Our Case Number: ABP-319866-24

Re: Proposed development known as North Irish Sea Array ("NISA") Offshore Wind Farm
Located off the coast of Counties Dublin, Meath and Louth (www.northirishsearraysid.ie)

RE: APPLICATION TO AN BORD PLEAN6LA UNDER SECTION 291 OF THE PLANNING AND DEVELOPMENT ACT 2000 (AS AMENDED) FOR PERMISSION FOR NORTH IRISH SEA ARRAY (NISA)

Observation 1 – In relation to Search and Rescue and other issues for consideration in relation to response emergency preparedness for Layout Option 1 & Option 2

Map of the northwestern area of the array showing the location of the gas pipeline – distance between the Gas pipeline and the array is only 400 metres

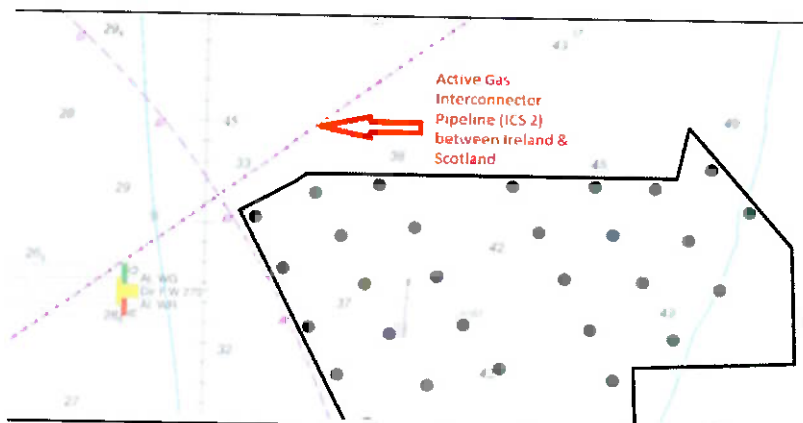
Part of IRCG's remit is pollution response, including Hazardous & Noxious Substances (HNS). The turbines in the northern western area of the proposed layout are very close to the Gas Interconnector Pipeline located on the seabed between Ireland and Scotland.

On page 44 of Environmental Impact Assessment Report Chapter 20 – Infrastructure & Other Users – the distance from the Gas Pipeline to the Array Area is measured at 0.5km. With a limit of deviation of 500 metres on all turbines, the distance between the turbines and the gas pipeline could be further reduced. There is a risk that the pipeline could be ruptured or damaged during construction within the wind farm.

IRCG propose that the three turbines in the Northwest corner, closest to the Gas Pipeline should be moved to a different location and that a safe distance is maintained between the other turbines and the gas pipeline. The pipeline is marked on the diagram below.

Paragraph 308 is incorrect. The Gas Interconnector pipeline shown on the diagram below is located (0.2nm) 400 metres from the array. The location of the Gas interconnector pipeline should have been included in the cumulative risk assessment. IRCG consider the pipeline to be a significant risk to the proposed development.
